MEETING SUMMARY
BRUNSWICK HYDROELECTRIC PROJECT

FERC NO. 2284

DOWNSTREAM FISH PASSAGE ALTERNATIVES MEETING

January 27, 2026

Alternative D1 - Angled Bar Rack with
New Downstream Pass Structures

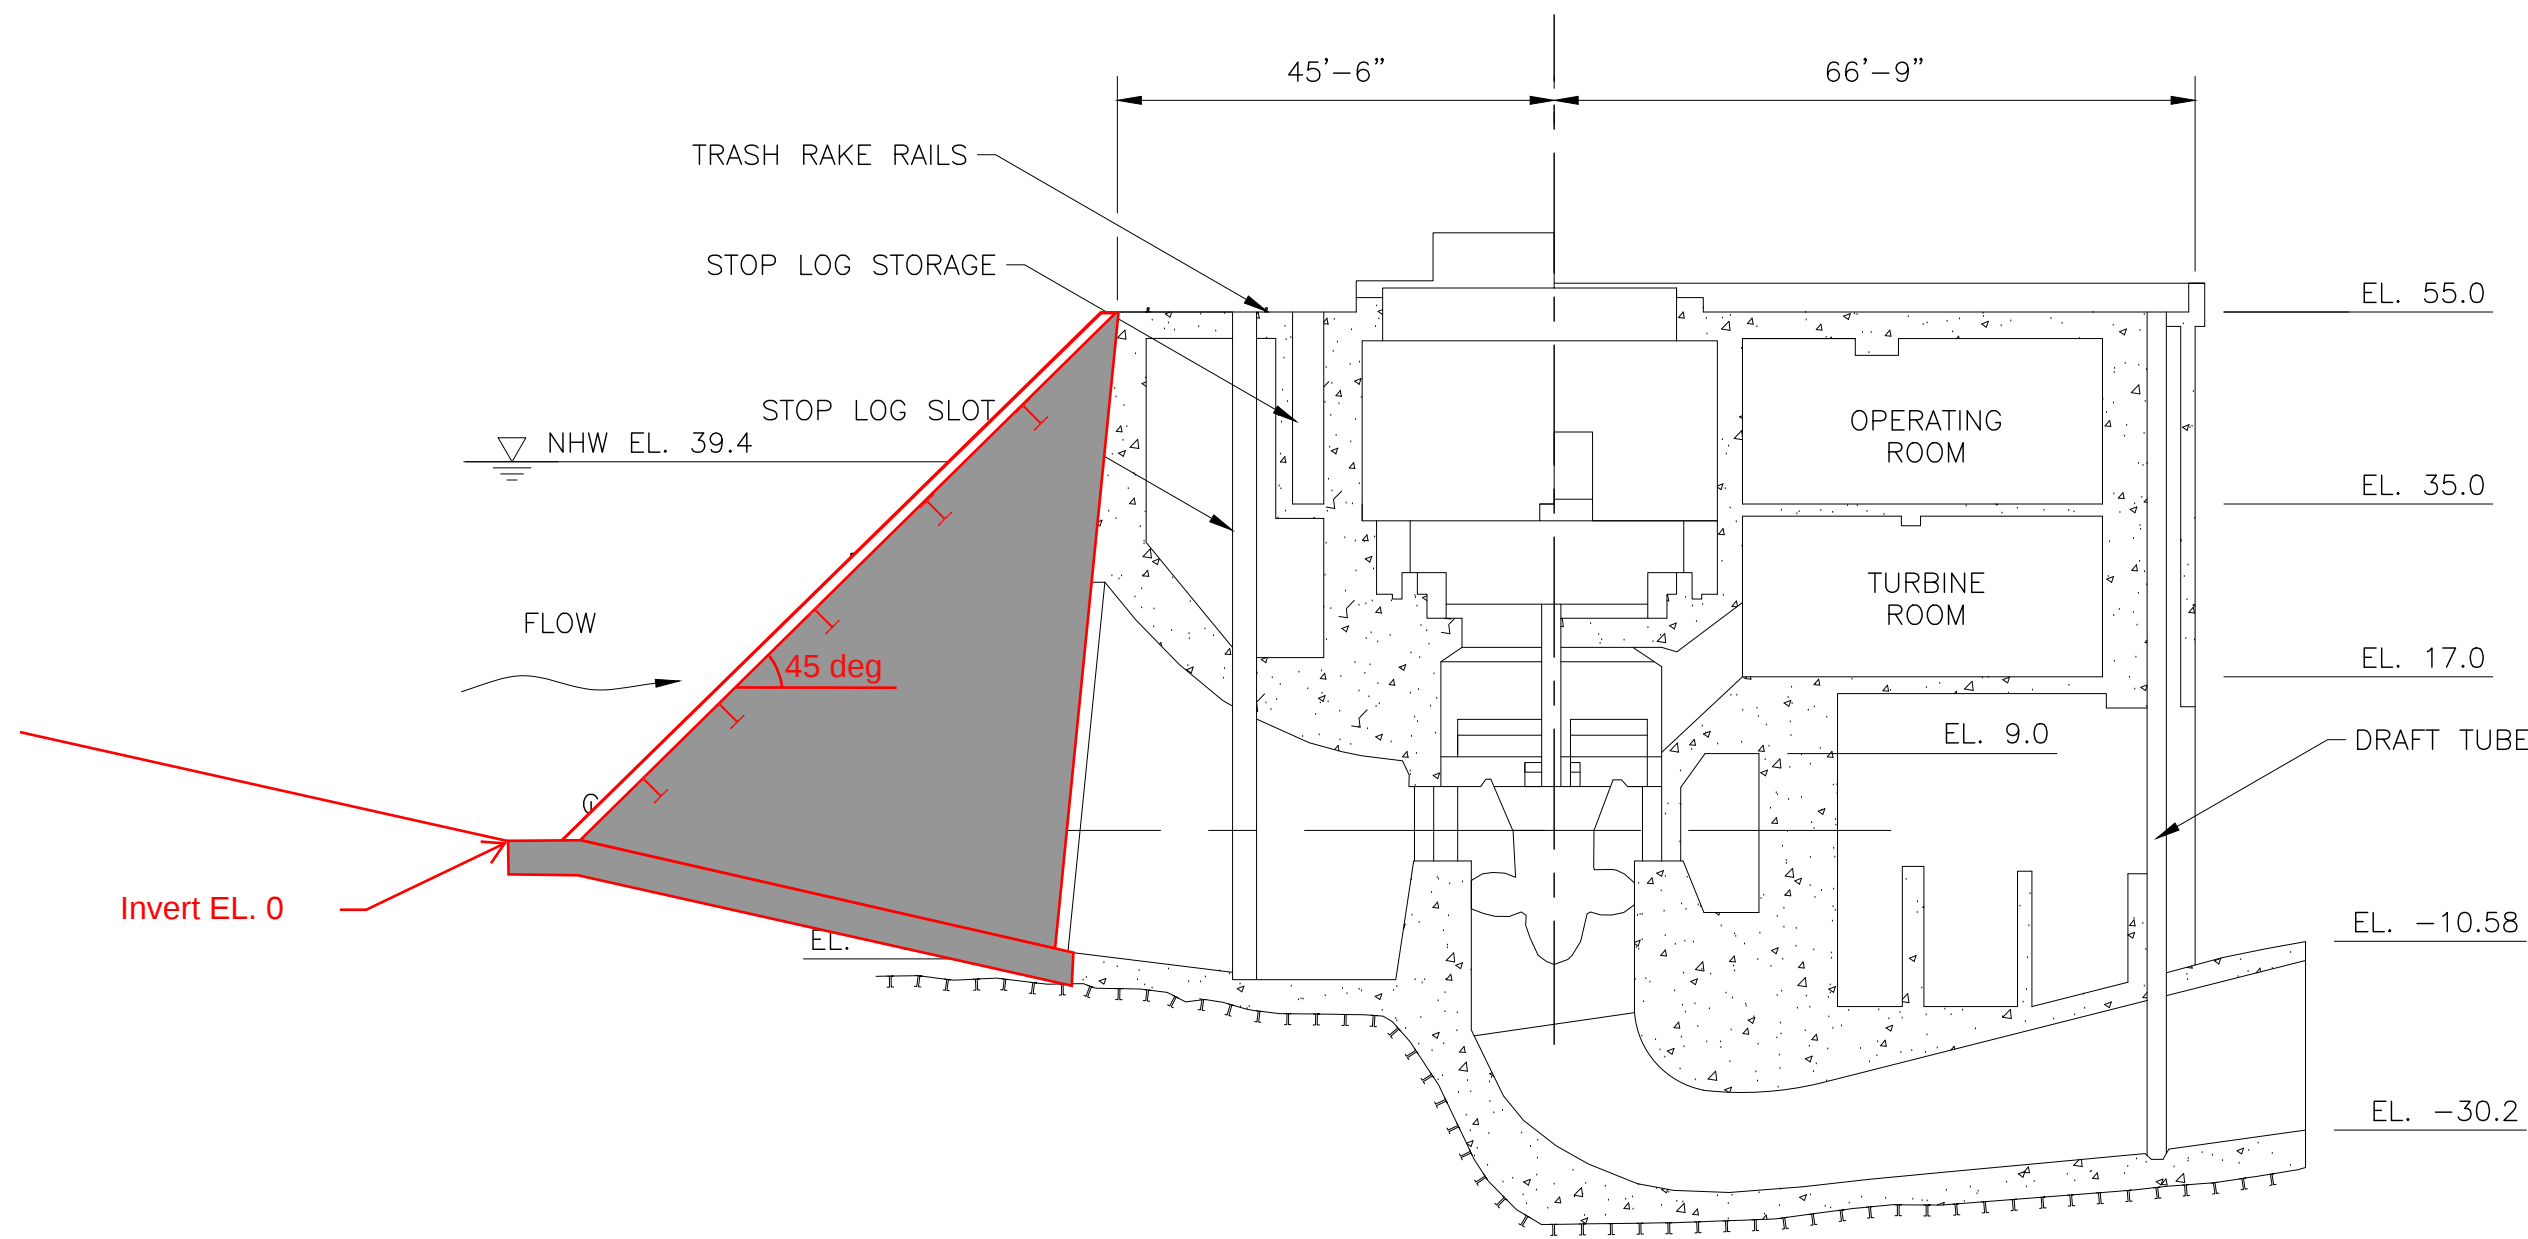
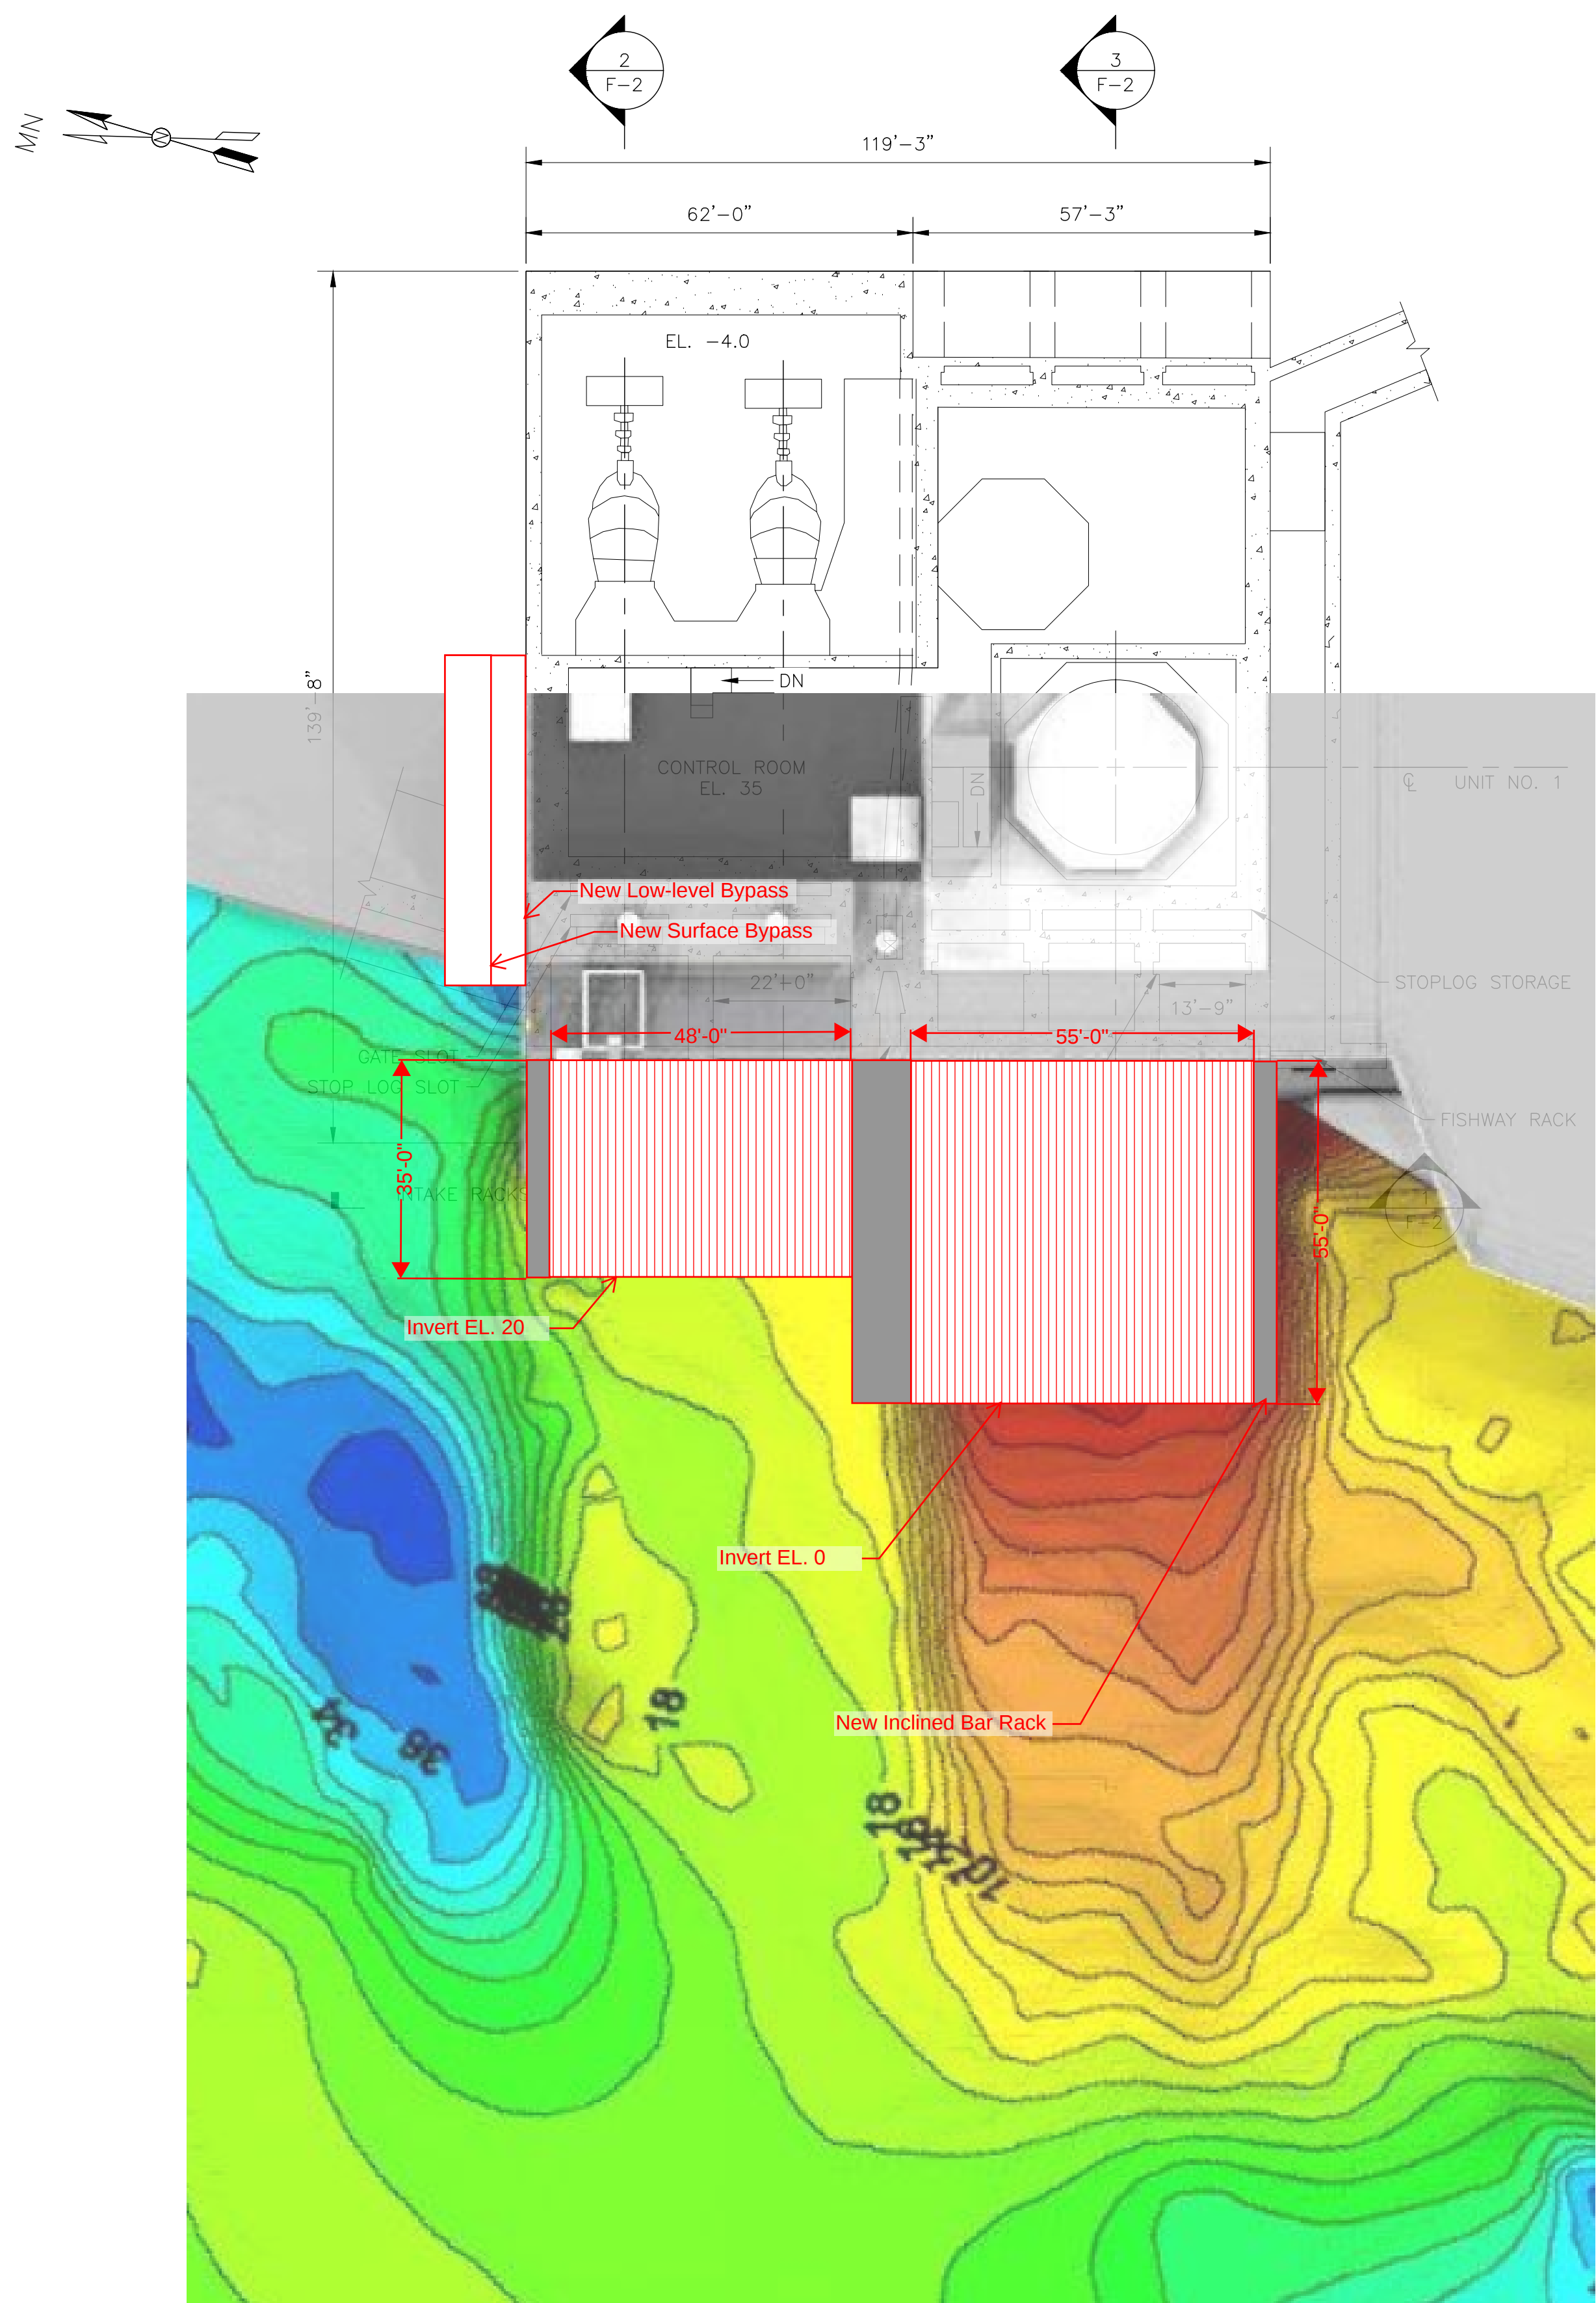
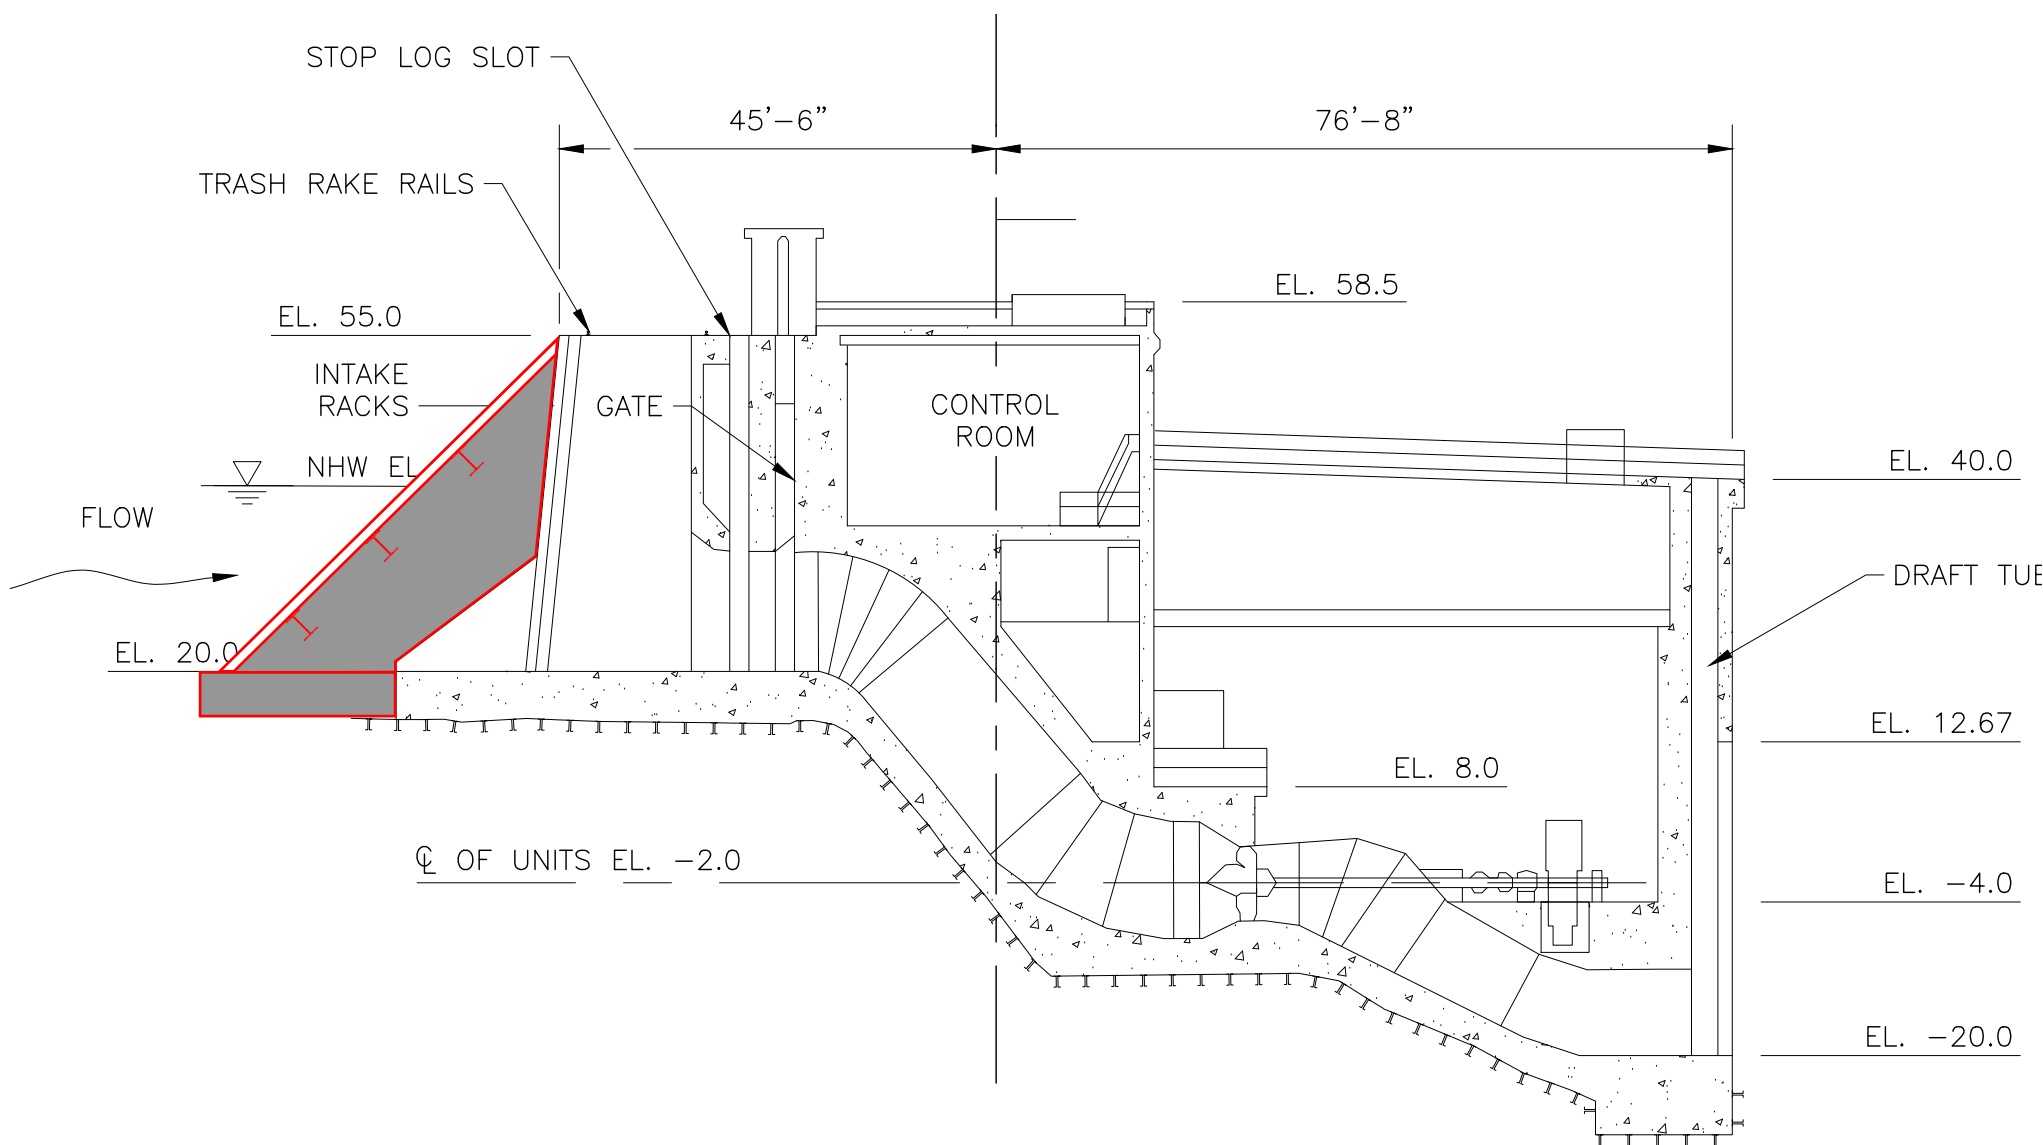
Don Dow asked why the rack was angled toward the spillway, rather than in the opposed direction toward the exit of the upstream fish ladder. Lucas replied that it was easier to place a bypass on the spillway near the north side of the powerhouse, and when the Project is spilling putting the bypass and angling the intakes over to the spillway side will be better from an attraction and guidance perspective. Don Dow stated that from a constructability perspective it would be easier to orient in the other direction but also agreed with Lucas's logic. Lars Hammer asked if the conceptual sketches being presented could be shared with meeting participants. Kirk Smith replied that the sketches would be shared after any Critical Energy Infrastructure Information (CEII) restrictions were clear with Brookfield. Lars Hammer asked what the source of the bathymetry in the sketches was. Lucas replied that the bathymetry was from the 2011 Blue Hill Hydraulics analysis, noting the differences in bathymetry data for the Blue Hill data, which was elevations, and the recent bathymetry data which was in terms of depth.

Don Dow stated that if there were a few velocity hotspots that developed, he could be accepting of that. He would expect velocities to be high over the entire face of the racks based on previous hydraulic modeling but that could be minimized by turning down the units.

Ed Friedman suggested that the rack spacing should be closer ½ inch to be protective of young-of-year fish and was wondering how a change could impact the other evaluation criteria. Lucas stated that such a change would have a substantial impact on operations and generation. Substantially, more manpower would be needed to keep the racks clean during the spring and fall. In the winter, impacts from frazil ice could be problematic to operations.

Don Dow stated that the criteria for salmon has been 1-inch clear spacing, which was conceived by USFWS back in the 1980s. More recently, USFWS has adopted ¾-inch clear spacing to be protective of American eel. Don Dow further stated that NMFS research has indicated that most downstream migrating wild and hatchery smolts in Maine range in size between ½-inch and one inch. Don said he is unsure what the smolts reaction would be to ¾-inch rack spacing especially at higher velocities, but he would feel secure that ½-inch would physically exclude smolts.

Lars Hammer asked if there was flexibility in the feasibility analysis to modify the configuration of an alternative if circumstances dictated it. Lucas replied that if CFD modeling or some other part of the analysis showed that a better outcome could be achieved, then the configuration (e.g., angle of the racks, etc.) could be reconsidered.
